1 Products affected

Change of material, V-Lock cord retaining feature as standard.

Product Change Notification					PCN 4798		
owner	creation date	release date	released by	change order no	rev	page	0118.2322
hotzar	2015-12-05	2016-03-14	stadelt1	2009470	A	1 of 2

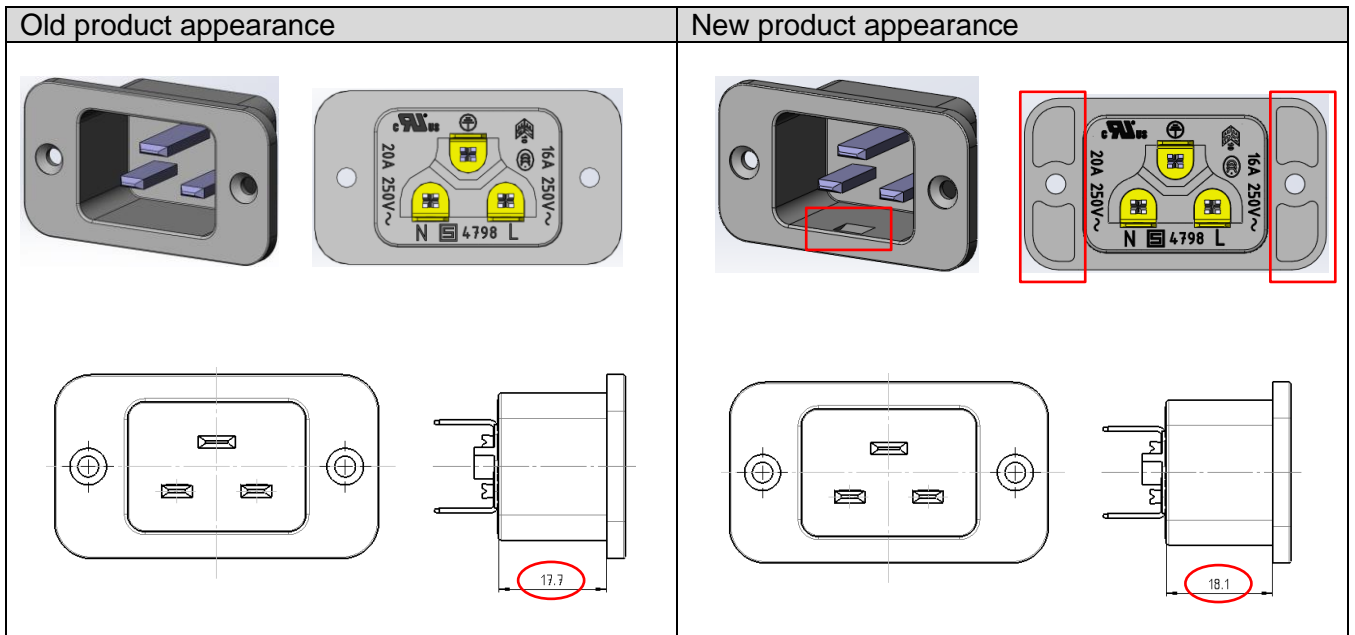
- Material change from PA6 to PA66/6 to pass the enhanced requirements of glow wire test acc. to IEC 60695-2-12 and -13
- V-Lock feature integrated as standard (not an option anymore)
- Flange will have a new form on the back side to improve molding process.

Form	Yes	Yes Socket has notch for V-Lock cord retaining, flange new form on the back side, extended socket dimension.
Fit	Yes	Yes, installation depth is 0.4 mm extended.
Function	Yes	V-Lock feature is standard (not an option anymore)
Production Site	No	There is no change of the production site
Product Label	No	No label change
Customer Action	No	Check installation depth in the application. Change SCHURTER part number if affected.
